Office Action Summary

10/576,913

TODD, ROGER KEITH

DETAILED ACTION

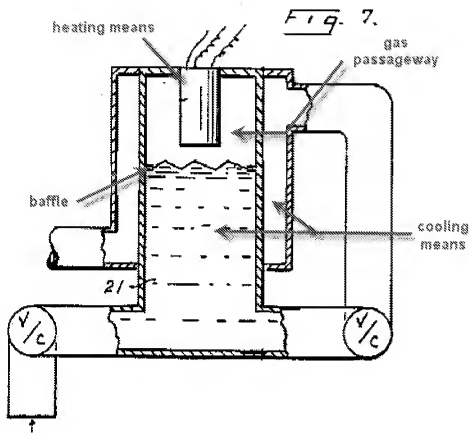
limitations from claims 4 and 21, wherein the pump body includes at least one baffle therein, the baffle defining a gas flow passageway between an inner wall of the pump body and the baffle, and wherein the gas flow passageway comprises a rising portion having the heating means arranged therein and a falling portion having the cooling means arranged therein (see FIG. 7 below as adapted by the examiner);

limitations from claims 6, 7 and 8, wherein the gas flow passageway comprises a circular annular passageway **(the chamber 21 is circular and the passageway formed at the top end as shown in the drawing above will be formed in an annular manner about the element 17);** comprising a substantially "P" or "Q" shaped passageway **(when viewed from above, the passageway around the element will appear as a substantially Q shaped passage);**

limitations from claims 9 and 11, wherein the pump body (FIG. 7) comprises a first part (A) including a volume of gas and a second part (B) including a volume of liquid; and a diaphragm (25) arranged in the second part of the body to separate the first and second parts **(C. 6 Lines 17-33);**

limitations from claims 19 and 20, wherein the heating means (17) is arranged above and offset laterally from the cooling means with no overlap **(see FIG. 7 with respect to the position of heating means 17 and the liquid which serves as the cooling means, relative to each other);**
